Our Ref: ABP-303726-19

Re: A mixed-use development which includes a six-storey hotel, six-storey car park, five-storey residential building, three five-storey office buildings, two-storey cultural/performance centre, two-storey mixed-use restaurant/café/specialist retail building, new sea wall around the existing Trinity Wharf site, 64 berth floating marina and all other site infrastructure works and ancillary works.
Trinity Wharf, Trinity Street, Wexford.

PROPOSED DEVELOPMENT AT TRINITY WHARF, TRINITY STREET, WEXFORD
Ref PL303726 - OBSERVATION/COMMENT TO AN BORD PLEANÁLA (ABP)

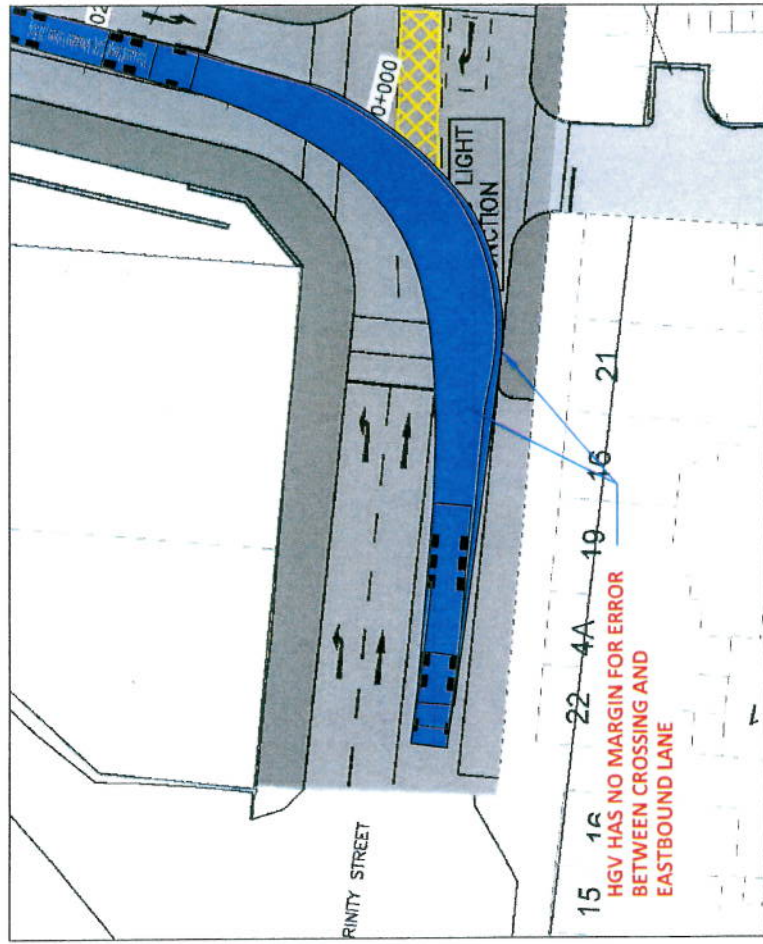
IT APPEARS THAT A HGV CANNOT MAKE THE LEFT OUT TURN FROM THE PROPOSED DEVELOPMENT

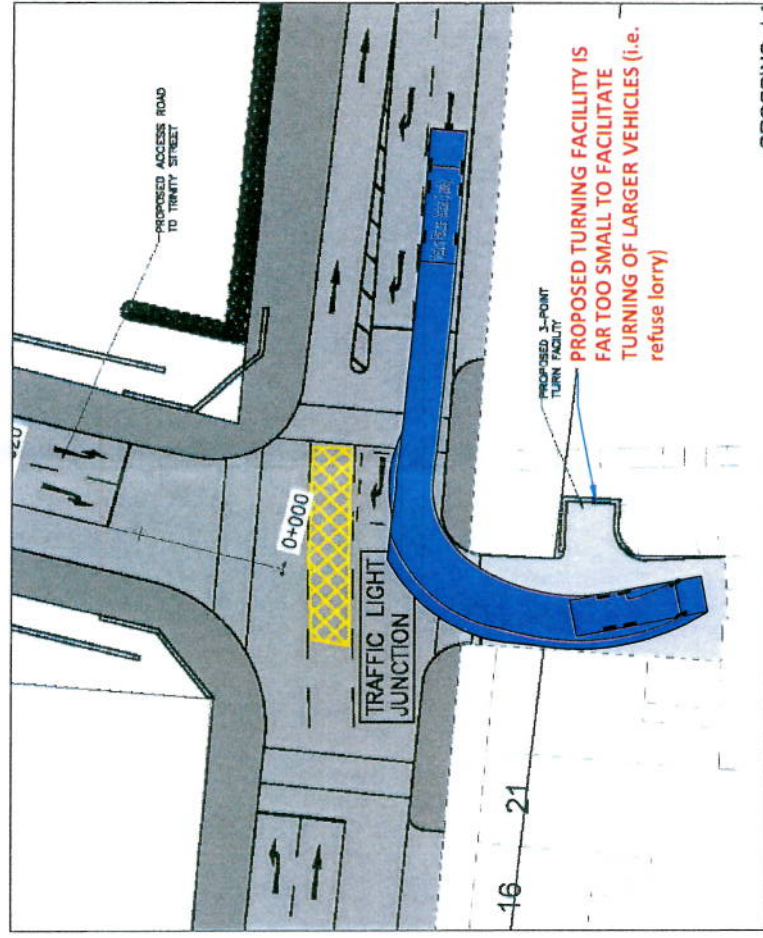
IT APPEARS THAT A HGV CANNOT JUST BARELY MAKE THE RIGHT OUT TURN FROM THE PROPOSED DEVELOPMENT WITH MINIMAL MARGIN FOR ERROR

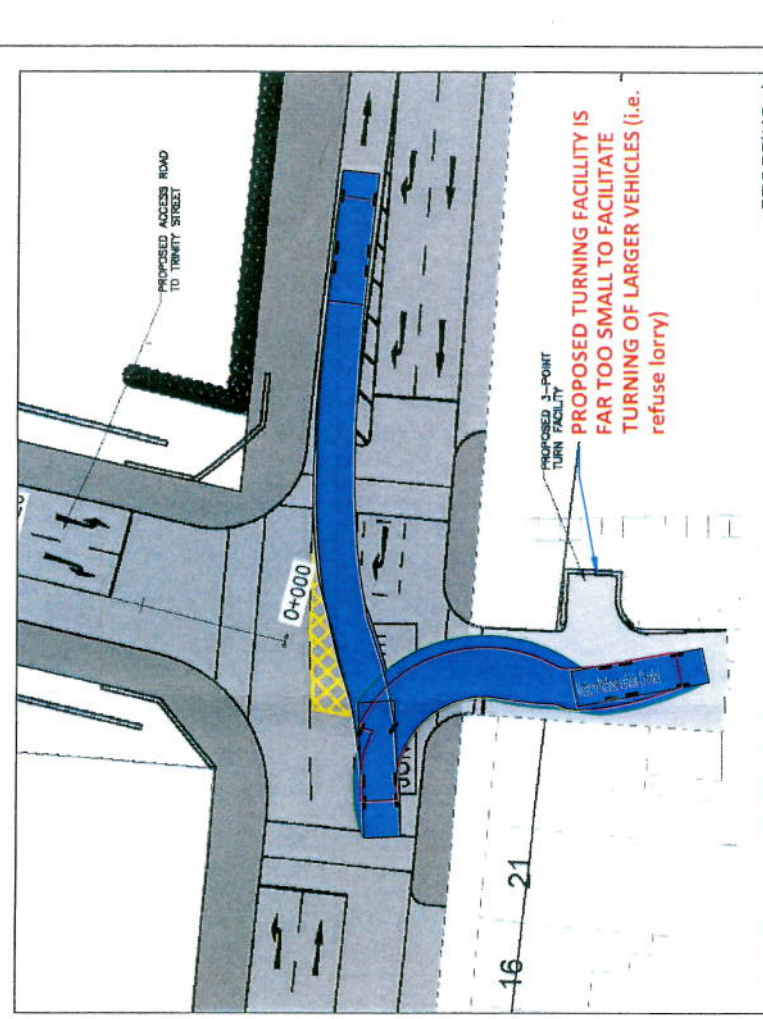
- Drawing NRB-AP-002 clearly illustrates that the design as currently proposed is deficient in terms of the Swept Path of Vehicle Types, with vehicles clashing with lanes in an unsafe manner.
- I would also highlight that a refuse lorry or fire tender will be unable to turn in a safe and appropriate manner within the current proposed turning head on Seaview Avenue - this will therefore require unsafe blind-reversing of these vehicles unexpectedly in the middle of a town centre Traffic Signal Controlled Junction.

REFUSE VEHICLES WILL NOW BE REQUIRED TO ENTER SEA VIEW AVENUE AS IT IS ILLEGAL FOR A VEHICLE TO SETDOWN IN A JUNCTION

REFUSE VEHICLES WILL NOW BE REQUIRED TO REVERSE INTO THE PROPOSED JUNCTION MAKING A SERIOUSLY UNSAFE MANOEUVRE

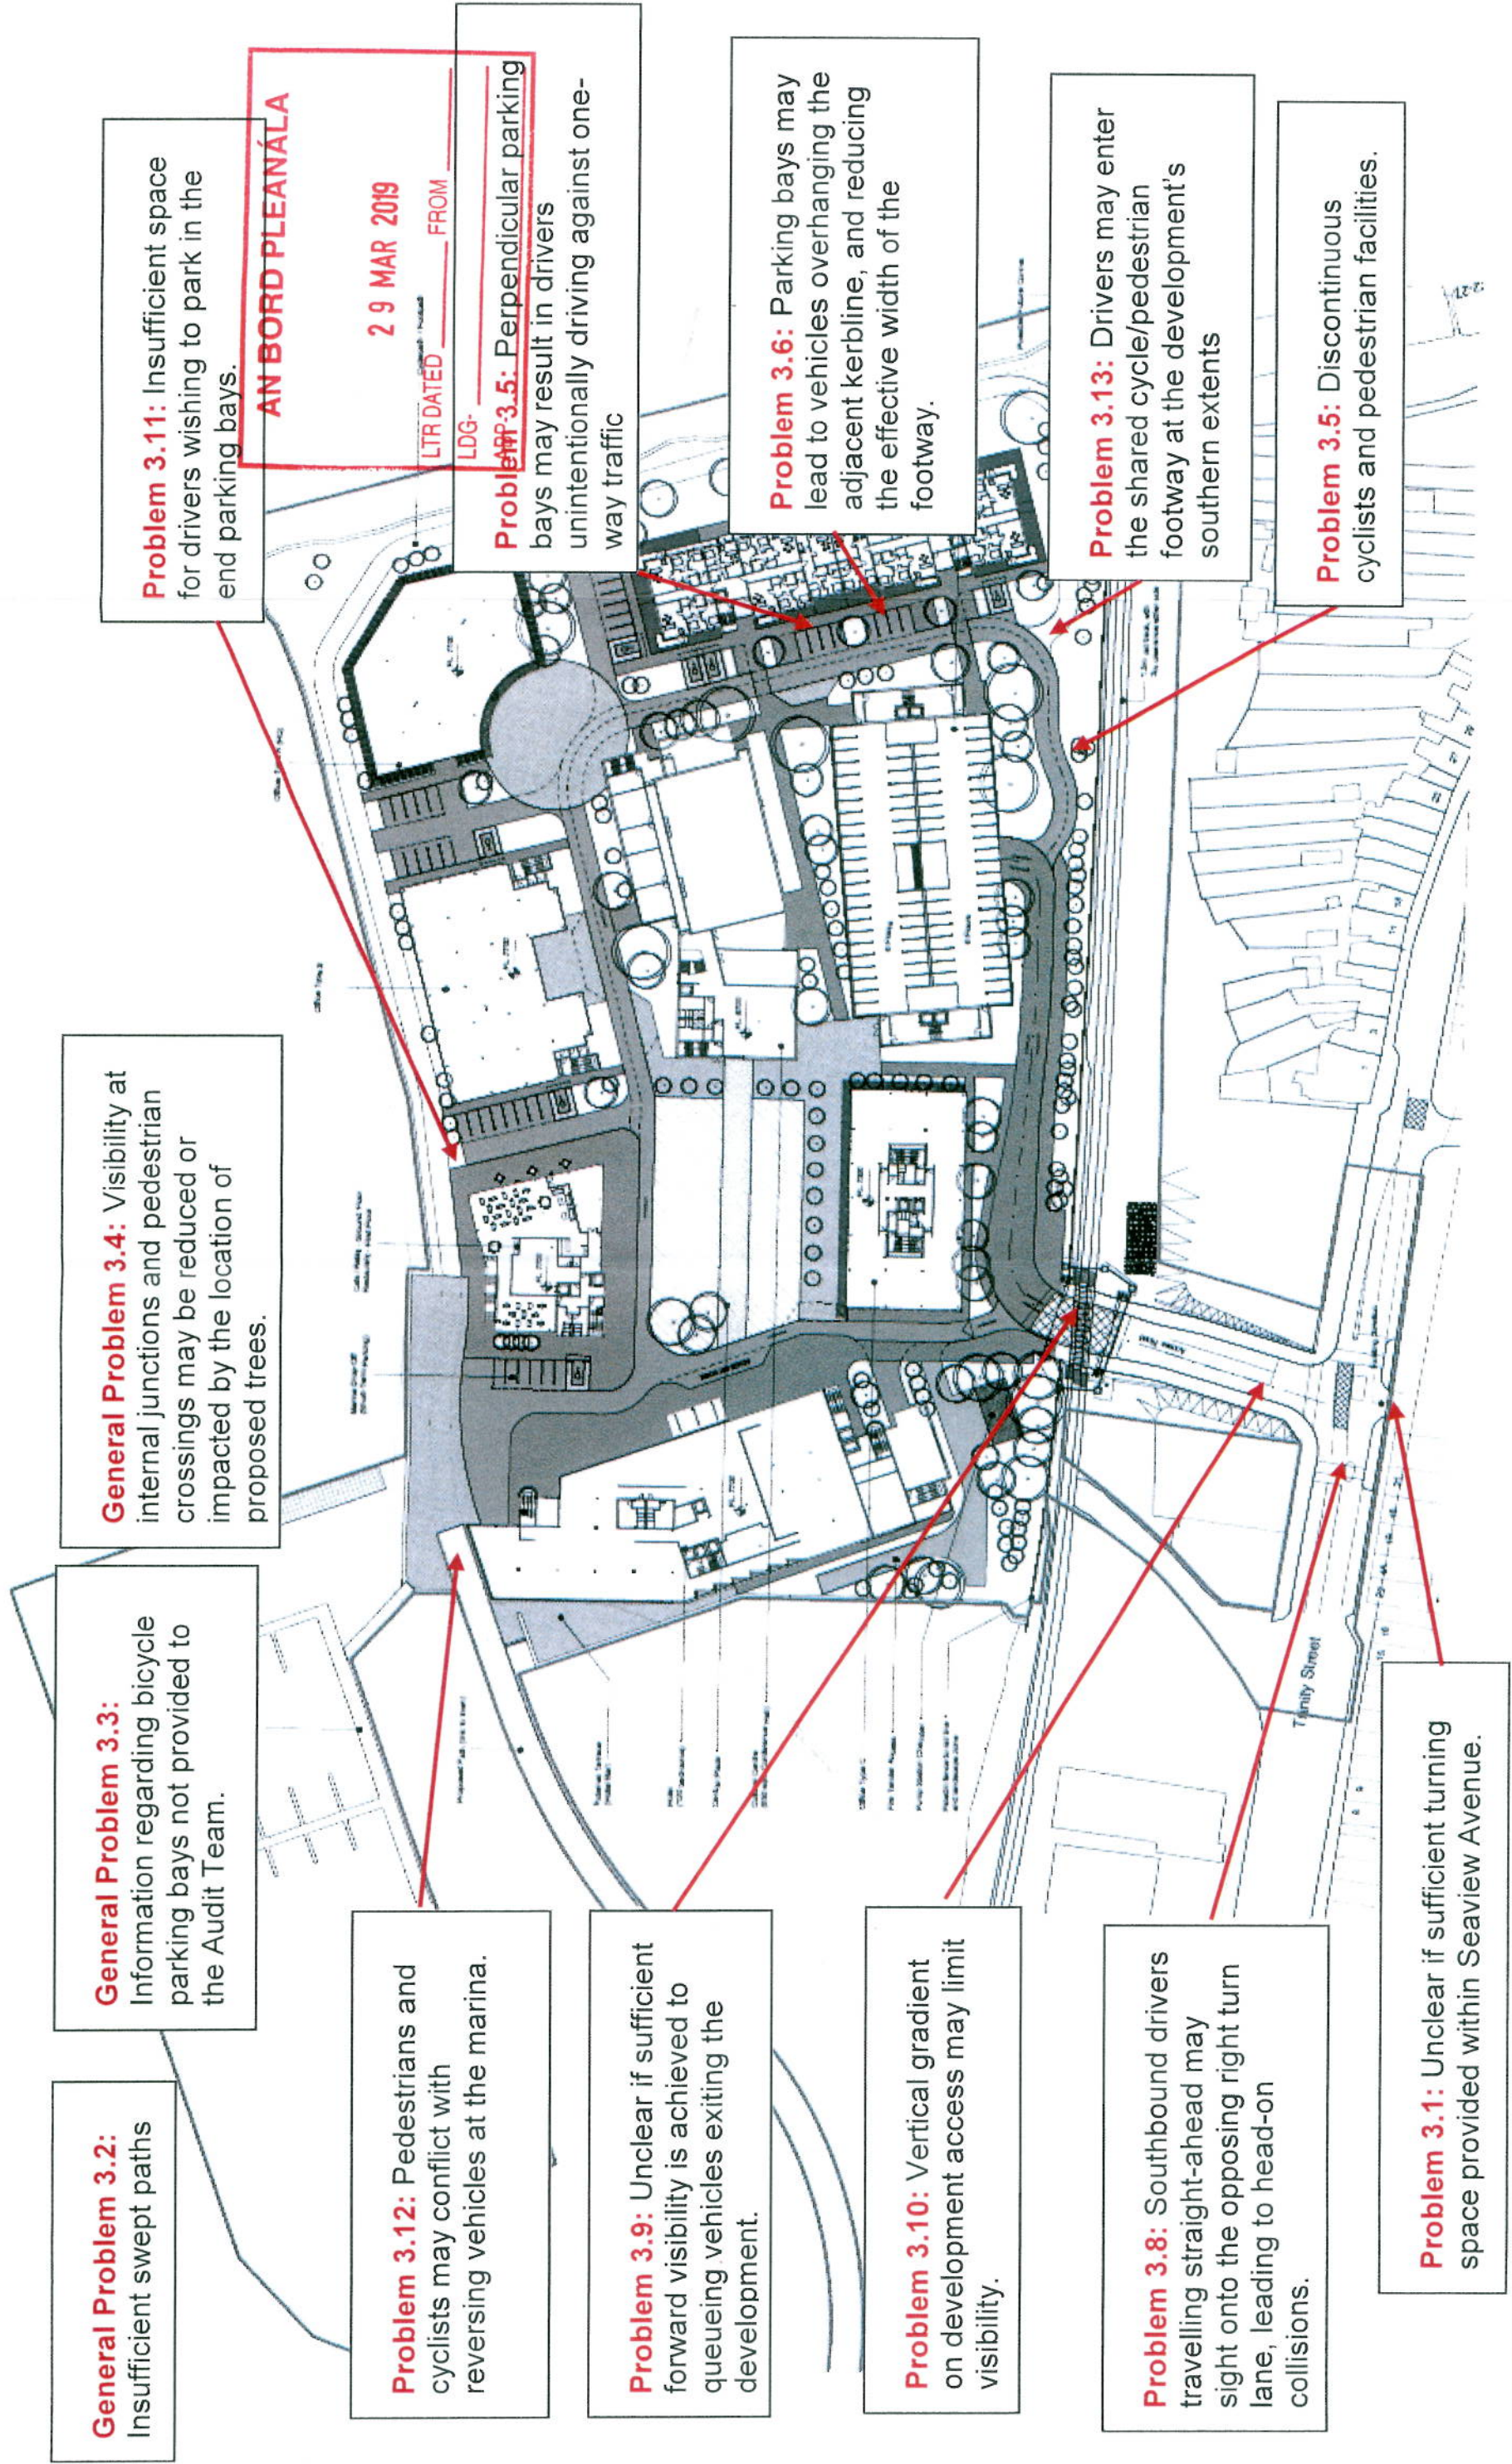
General Problem 3.2: Insufficient swept paths

General Problem 3.4: Visibility at internal junctions and pedestrian crossings may be reduced or impacted by the location of proposed trees.

Problem 3.12: Pedestrians and cyclists may conflict with reversing vehicles at the marina.

Problem 3.9: Unclear if sufficient forward visibility is achieved to queuing vehicles exiting the development.

Problem 3.10: Vertical gradient on development access may limit visibility.

Problem 3.8: Southbound drivers travelling straight-ahead may sight onto the opposing right turn lane, leading to head-on collisions.

Problem 3.1: Unclear if sufficient turning space provided within Seaview Avenue.

Problem 3.11: Insufficient space for drivers wishing to park in the end parking bays.

Problem 3.5: Perpendicular parking bays may result in drivers unintentionally driving against one-way traffic

Problem 3.6: Parking bays may lead to vehicles overhanging the adjacent kerbline, and reducing the effective width of the footway.

Problem 3.13: Drivers may enter the shared cycle/pedestrian footway at the development's southern extents

Problem 3.5: Discontinuous cyclists and pedestrian facilities.
